## Addendum No. 2 – Stage II

Reference: Salina Maintenance Facility  
Utah Department of Transportation – Salina, Utah  
DFCM Project No. 12335900

Subject: **Addendum No. 2**

**SANDER RACK  
 PLANS, SECTIONS  
 & ELEVATIONS**

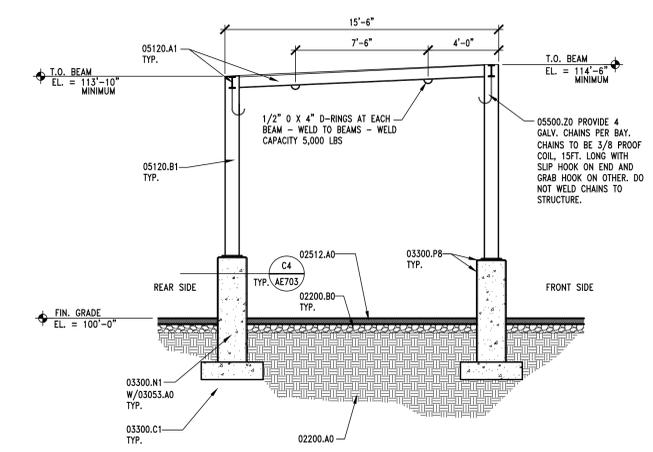
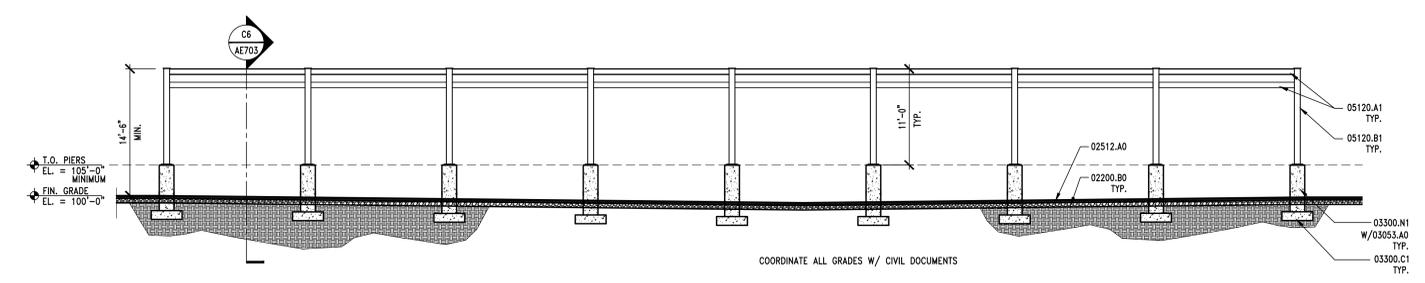
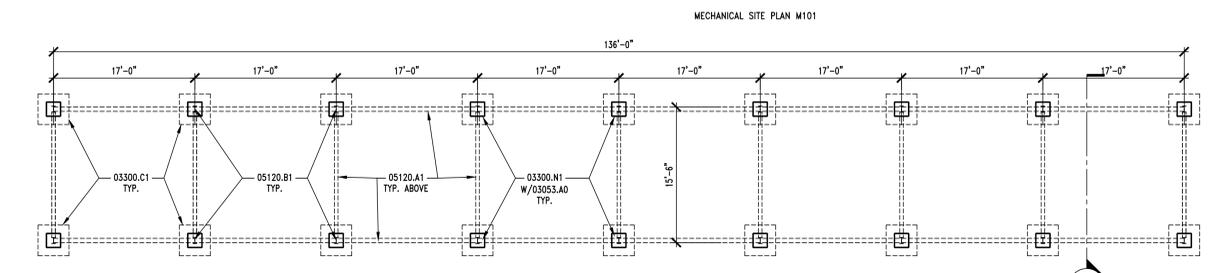
2.2.7 Question: Can UDOT supply a detail of the wash racks and sander racks required at this site?

*Answer: See attached drawings.*
